SERVICE BULLETIN NO: 32-001

MODIFICATION NO: EC-06-0104

LANDING GEAR LOCKING PLATE ATTACHMENT SCREW - REPLACEMENT

Replacement of the Locking-Plate Attachment Screws and Installation of the Placard
Figure 1

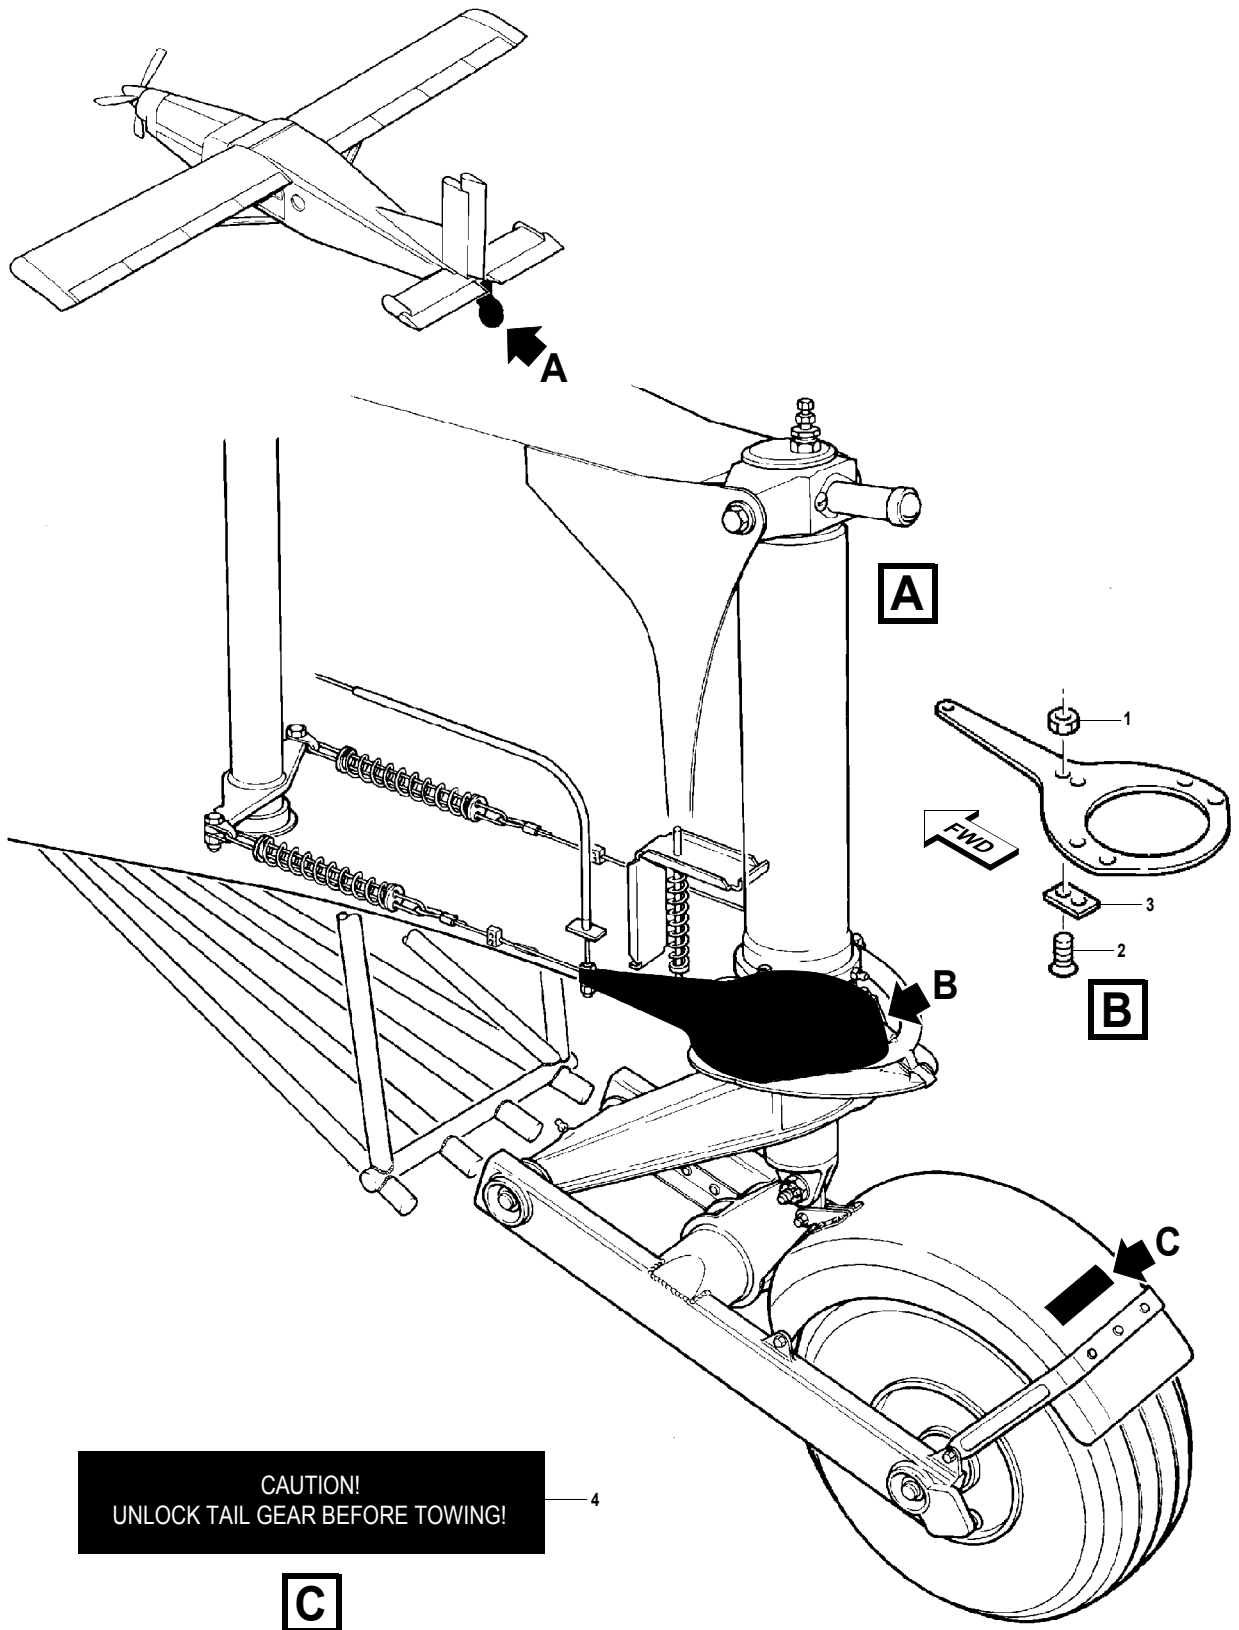
On the aircraft which had the incident, the pilot had selected "wheel locked" for the landing, but the attachment screws of part of the mechanism had sheared and the locking plate had become detached, thus preventing the tail wheel locking.

- (a) Replace the screws which attach the locking plate (P/N 6403.0095.01 or P/N 114.45.06.080) to the locking lever (P/N 6403.0094.00 or 114.45.06.077) with steel screws (P/N 933.11.31.046).
- (b) Install the "UNLOCK TAIL GEAR BEFORE TOWING" placard.

- (1) Hold the screws (2) and remove the nuts (1). Discard the nuts (1).
- (2) Remove the screws (2) and the locking plate (3). Discard the screws (2).
- (3) Do a check of the locking plate (3):
Either:

- (a) Make sure the holes in the locking plate (3) are 5 mm (0.197 in.) diameter. If necessary, use a 5 mm (0.197 in.) diameter drill to make the holes bigger (Ref. Repair and Overhaul Manual, Chapter 2).

- (b) Make sure the countersink for the holes in the locking plate (3) is 90 degrees. If necessary, use the correct countersink tool to make the 90 degree countersink in each hole (Ref. Repair and Overhaul Manual, Chapter 2).

- (4) Put the locking plate (3) in position and install the new screws (P/N 933.11.31.046) (2) and the new nuts (P/N 938.07.31.105) (1).
- (5) Move the tail-wheel handle to the STEER position and make sure the screws (2) do not touch the bearing plate when the tail wheel is moved. If the screw (2) touch the bearing plate, shorten the screws (2) as necessary.

- (1) Use the cloth (Material No. P02-003) made moist with the solvent (Material No. P01-002) and clean the area where the placard (P/N 110.71.06.675) (4) will be installed.
- (2) Remove the backing paper and bond the placard (P/N 110.71.06.675) (4) in the position shown in Detail C.
